# FlexPLI weight tolerances

Reduction of proposed weight tolerances

## FlexPLI weight tolerances

Proposal for reduced FlexPLI assembly tolerances

### Assessment of the weight of available FlexPLI's

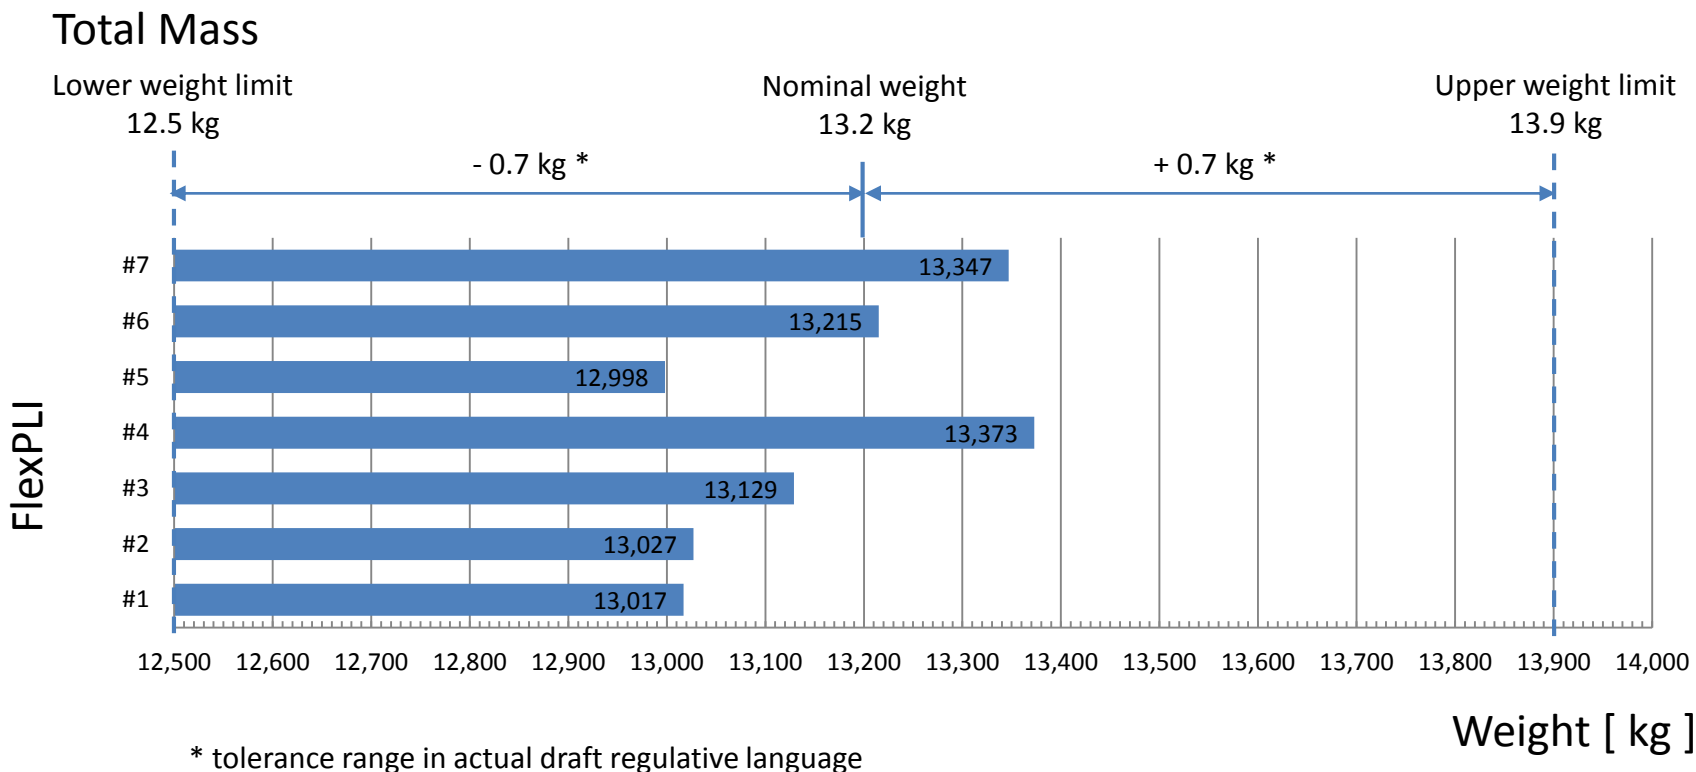
- Possible maximum weight range of 1.4 kg represents more than 10% of the total weight of the FlexPLI
- Tolerances incorporate different sensor equipment for different FlexPLI's
- The tolerances of the assembled mass of the femur, the knee joint and the tibia are calculated by summarization of the tolerances of the subassemblies

target weight GTR9	FlexPLI							mean values	max deviation
		#1	#2	#3	#4	#5	#6	#7		
total weight of FlexPLI in testing order	13.2	<b>13.017</b>	<b>13.027</b>	<b>13.129</b>	<b>13.373</b>	<b>12.998</b>	<b>13.215</b>	<b>13.347</b>	<b>13.139</b>	<b>0.375</b>
Assembled mass of the femur, the knee joint and the tibia, without the flesh and skin	9.38	9.207	9.242	9.219	9.522	9.24	9.445	9.520	9.298	0.315
total weight of neoprene covers (N1F + N1T + N2F + N2T + N3)		0.979	0.970	0.932	1.051	0.967	0.991	0.946	0.980	0.119
total weight of rubber sheets (R1+R2)		2.780	2.764	2.915	2.8	2.745	2.730	2.833	2.801	0.151

- Weight tolerance of  $\pm 0.35$  kg for total FlexPLI
- Weight tolerance of  $\pm 0.23$  kg for assembled mass of femur, the knee joint and the tibia without the flesh and skin

Figure 12  
of doc.  
UNECE/TRANS/WP.29/GRSP/2013/25

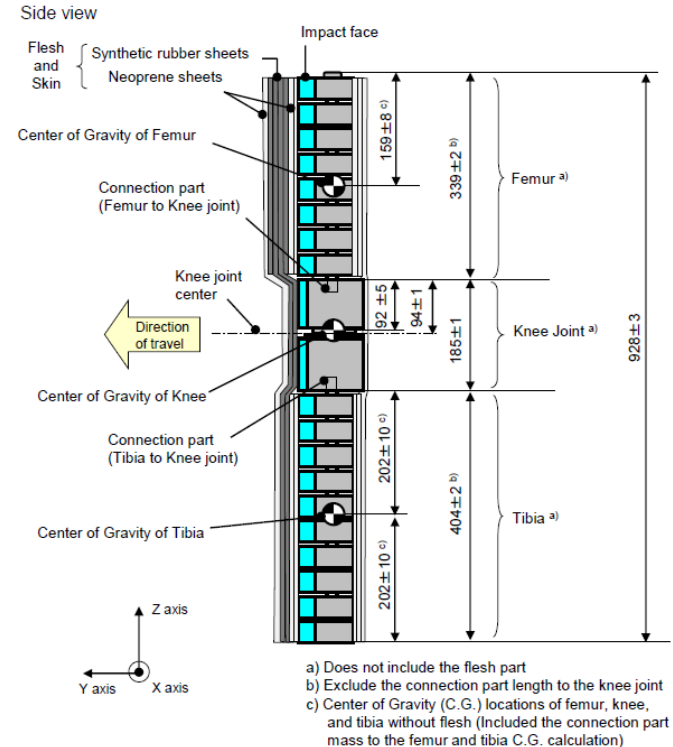
- Unchanged tolerances for femur, tibia and knee subassemblies (position of center of gravity of FlexPLI)

#### Total Mass

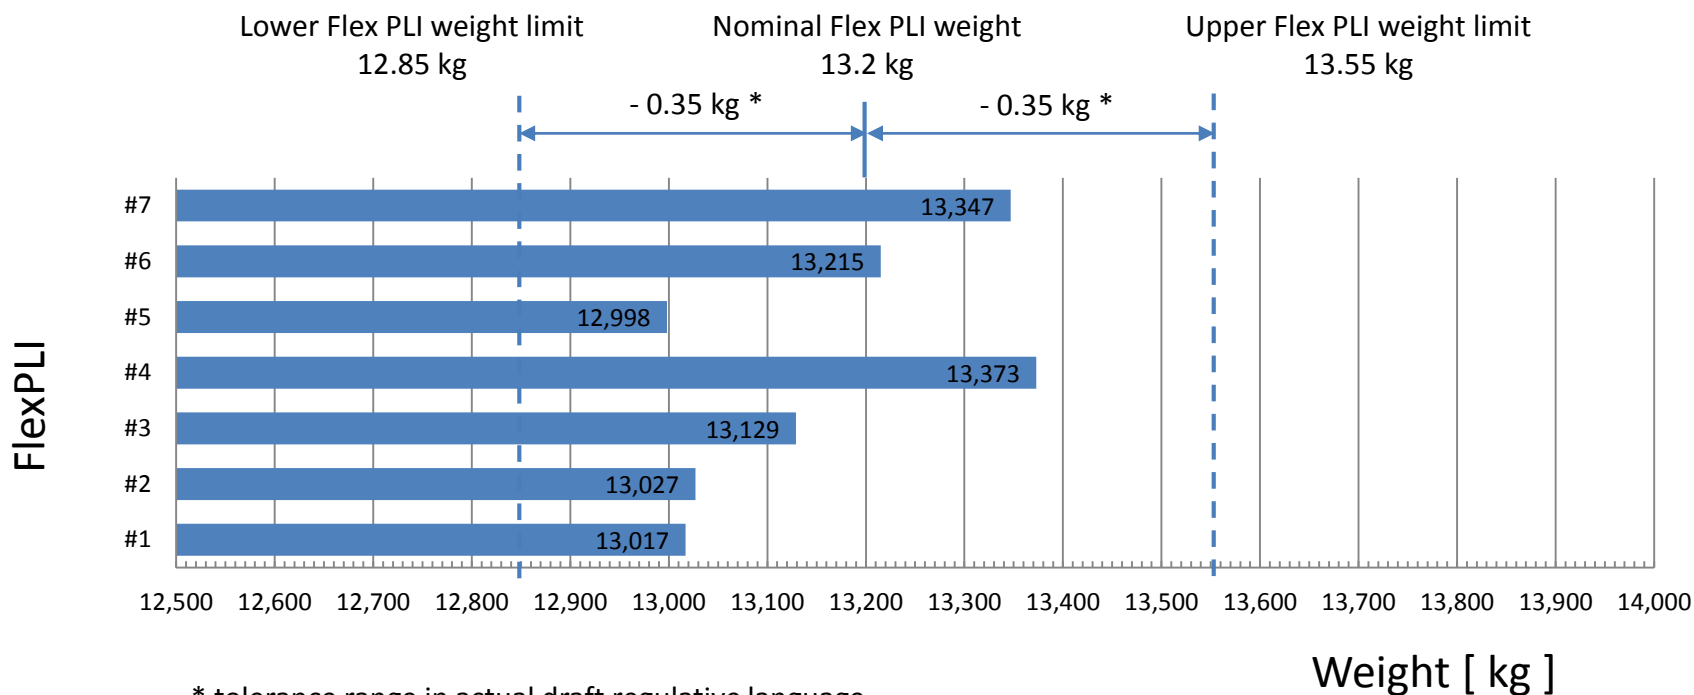
### Proposal for reduced FlexPLI weight tolerances
